<b>Well Name:</b> GANTRYPerson FEDERAL	<b>Well Location:</b> T19S / R33E / SEC 15 / NWNW /	<b>County or Parish/State:</b> LEA / NM
<b>Well Number:</b> 3	<b>Type of Well:</b> OIL WELL	<b>Allottee or Tribe Name:</b>
<b>Lease Number:</b> NMNM36915	<b>Unit or CA Name:</b>	<b>Unit or CA Number:</b>
<b>US Well Number:</b> 300253626100S1	<b>Well Status:</b> Oil Well Shut In	<b>Operator:</b> COG OPERATING LLC

### Notice of Intent

**Type of Action:** Plug and Abandonment

## PLUG AND ABANDONMENT CONDITIONS OF APPROVAL

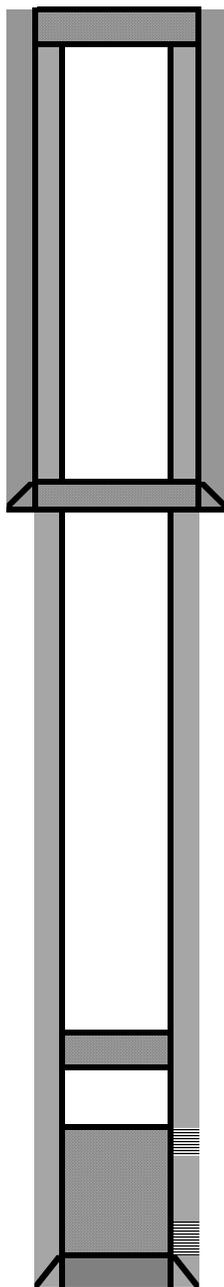
7. Perf & Sqz 25 sx cmt @ 60' to surface through 5 1/2" & 8 5/8" annulus.

3. Spot 110 sx cmt @ 3770-3240'. WOC & Tag @ 3240' or above. (7 Rvs & Yates)

<b>COG Operating LLC</b>		<b>PROPOSED</b>	
Author:	Abby @ BCM	Well No. #3	
Well Name	Gantryperson	API #: 30-025-36261	
Field	Tonto	Prop #: 29887	
County	Lea	Zone: Seven Rivers	
State	New Mexico	330 FNL & 990 FWL	
Spud Date	8/6/2003	Sec 15 T19S R33E	
GL	3670'		
KB	16'

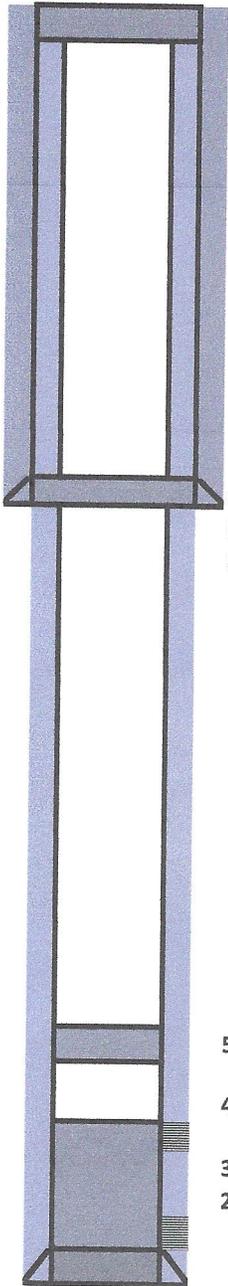
7. Perf & Sqz 25 sx cmt @ ~~60'~~ to surface through 5 1/2" & 8 5/8" annulus.

160'

Verify @ surface

WOC & TAG

3. Spot 110 sx cmt @ ~~3770-3240'~~ WOC & Tag @ ~~3240'~~ or above. (7 Rvs & Yates)

(3770' to 3210')

2. Drill out CIBP @ 3630' w/ 10' cmt on top & tag PBTB.
3. Spot 110 sx cmt @ 3770-~~3240~~<sup>3210</sup>'. WOC & Tag @ ~~3240~~<sup>3210</sup>' or above. (7 Rvs & Yates)

7. Perf & Sqz 25 sx cmt (~~3~~<sup>100</sup>) to surface through 5 1/2" & 8 5/8" annulus. *Verify @ surface*
8. Cut off well head, verify cmt @ surface, weld on Below Ground DHM.
